Re: In the Matter of Commonwealth Edison Company
(Braidwood Station, Units 1 and 2, Docket
Nos. 50-456 and 50-457 *DL*)

Material Traceability Verification at Braidwood

Subject: Braidwood Generating Station Units
1 and 2
Material Traceability Verification
Program
NRC Docket Nos. 50-456 and 50-457

EPRATA

Page I-6, Lower-right two boxes

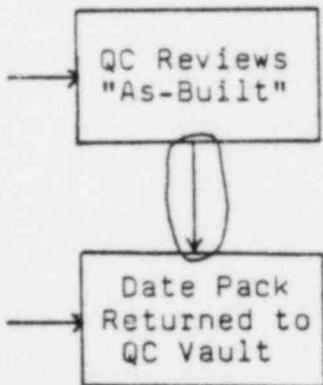
The changes made to Reference (a) are either underlined or circled, and deletions are shown with dashes through them.

Page I-1, Second Paragraph:

It was reported in NRC Inspection Report 83-09 that verification of material traceability may have been performed by quality control inspectors. Documentation of those inspections was not generally available. Because, in the Staff's view, undocumented inspections are not an appropriate means for satisfying the NRC's Quality Assurance Criteria, ~~and as~~ such inspections cannot be relied upon. Hence, the NRC Staff concluded that a violation of Criterion X had occurred.
